**Item 3.****Development Application: 29-43 Balfour Street, Chippendale**

File No.: D/2018/1097

**Summary****Date of Submission:** 13 September 2019**Applicant:** Mr D Klien  
c/: Ethos Urban**Architect:** SJB Architects**Owner:** NMI Holdings Pty Ltd**Cost of Works:** \$2,997,500**Zoning:** B4 Mixed Use zone - alterations and additions to the existing commercial building are permissible with consent**Proposal Summary:** The application seeks consent for the demolition of an existing mezzanine level and replacement with an additional storey, relocation of plant, creation of new roof terraces and internal works to the existing office building at No.29-33 and No.35-43 Balfour Street, Chippendale (known as 'the site').

Figure 18: Proposed location of the plant

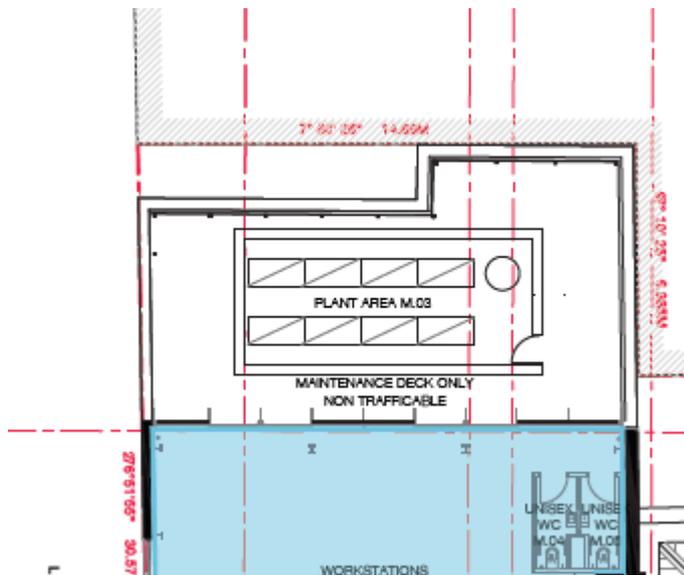
43. The application proposes to relocate the air conditioning condensers from the centre of the site and to the non-trafficable rear (western) roof terrace. The proposal includes a 2.1m high acoustic screen around the plant.

44. The applicant has submitted an acoustic report which has been peer reviewed as well as being assessed by Council's Environmental Health Unit.
45. The application states that the location of the plant is the best location available given the roof forms, amount of plant required for the building and the need to limit visibility from the street. The acoustic report details that the proposal will remain well below the maximum permitted noise of 59dB(A) for the nearest residential receiver. The acoustic report states that the predicted noise from the mezzanine (including plant) is 48dB(A).

48. The proposed location of the plant and the use of the front roof terrace is capable of complying with Council's requirements. Conditions of consent have been recommended including noise level requirements for plant and restricted capacity and hours for the use of the terrace.

**Figure 19:** Detailed section

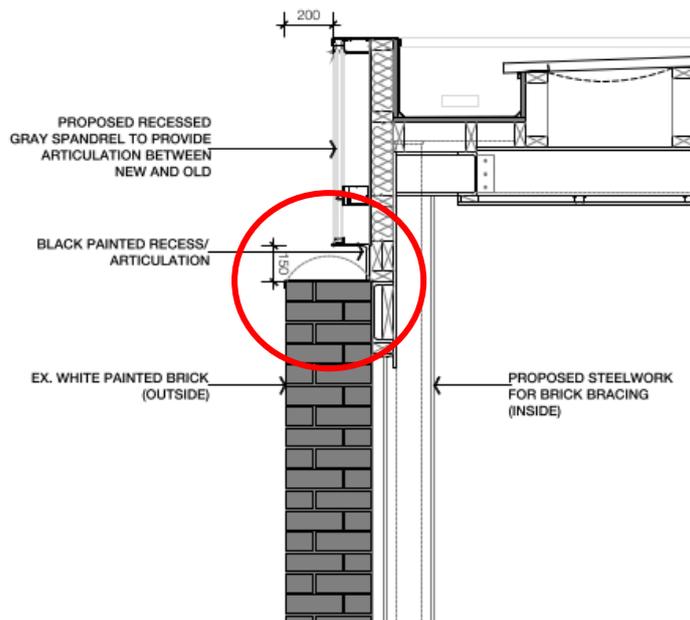
51. Through the assessment of the application Council raised concerns regarding the floor level of the addition which sought to retain the existing mezzanine's floor level that intersects with the arched windows of the floor below on the Little Queen Street elevation. Details of the proposal have been subsequently provided to show that the floor level will be raised to predominately sit above the glazing. However, given the arched shape of the windows, there will be some structure visible at the apex of the arch however this will largely be concealed by the window frame and will be setback from the window. Council's heritage specialist is satisfied that this will not result in detrimental impacts on the character and significance of the contributory item.

52. The nil setback to Little Queen Street is not supported on heritage grounds. While the shadow line and 200mm setback from the external face of the original wall is noted, the feasibility of this detail is questioned. The proposal will result in a gap which is susceptible to water damage and accumulation of debris. This area is likely to be flashed over resulting in the loss of the curved capping which is a key feature of the contributory building.

53. It is therefore recommended that the addition be setback a total of 600mm from the external face of the southern wall. This will result in a small loss of usable floor space (approximately 6sqm) due to the required low height of the box gutter, however this would continue to permit sufficient usable floor space within the mezzanine. This will also reduce the addition's visibility from Little Queen Street. A condition of consent to require the submission of amended plans incorporating these details prior to Construction Certificate is recommended.
54. Overall, the proposal generally complies with the relevant aims, objectives and controls of the DCP subject to conditions as discussed.
